# BULLETIN

## CARLYLE COMPRESSOR DIVISION

Number: 03T-1

**Update 06E & 06T Terminal Wiring Instructions**

**FIGURE 1: 06E, 06CC & 06T TERMINAL BOX & WIRING**

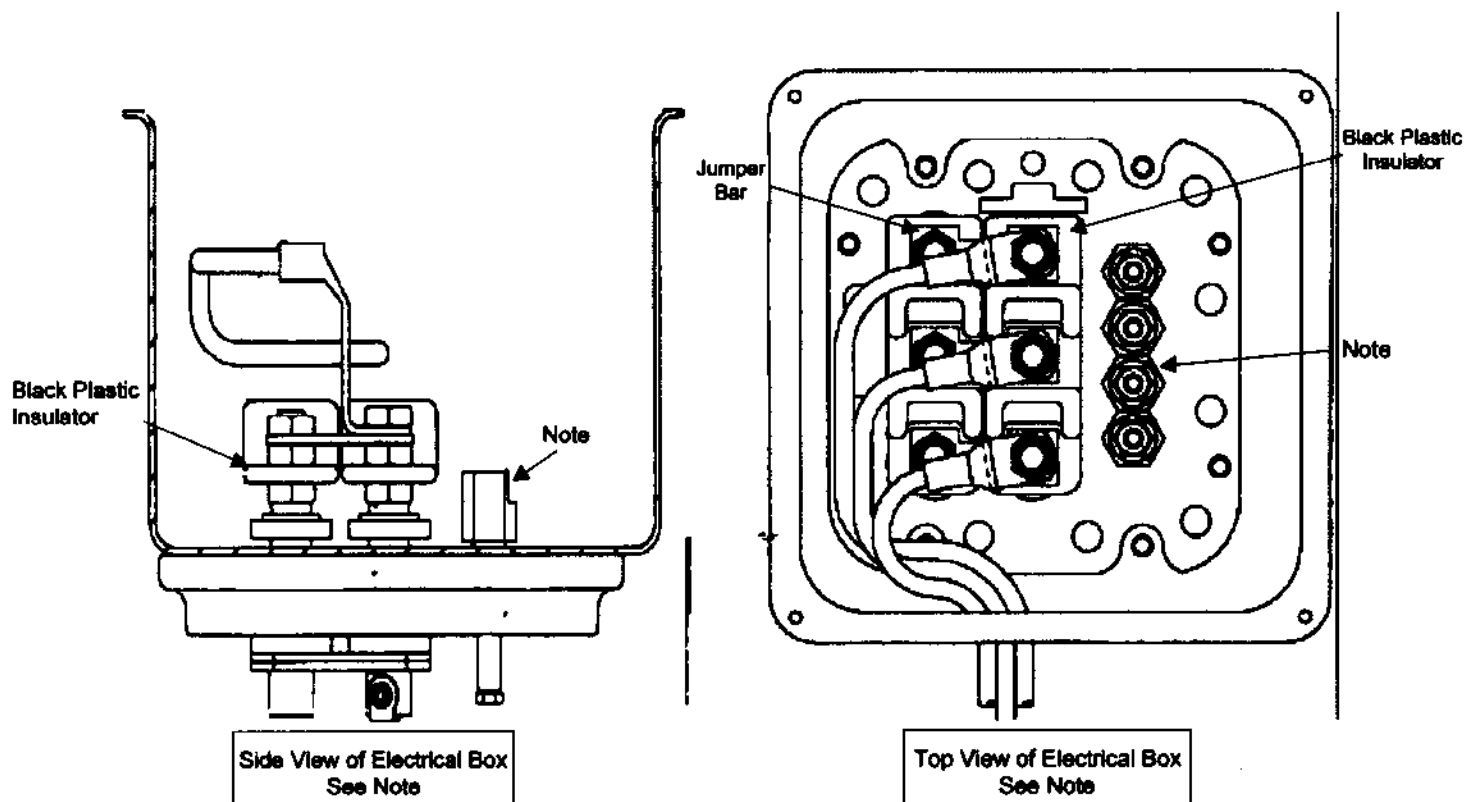
- Allowed on any terminals where a jumper bar is used over jam nut #2 (See figures 1 thru 7 attached). This allows the increased torque to any across-the-line wiring arrangements shown in attached figures 3 & 4 on all current and older compressors.

- Terminals T4, T5 & T6 will always have a jumper bar applied with them. Therefore higher torque can be applied without adding any loctite. These terminals may also have the plastic isolator removed to add the 3-hole jumper as shown in Figures 4 & 7. Loctite will not be applied to these terminals at Carlyle for this reason nor is it recommended in the field.

The purpose of this change is to ensure the power wiring is secure in the field. Our 98T-1 Bulletin recommended up to 12 ft-lbs torque to tighten the power wiring (jam nut #3). We are now increasing this torque up to **18 ft-lbs max** and dropping our requirement of adding loctite to the #3 jam nut. This increase in allowable torque is based on the following limitations:
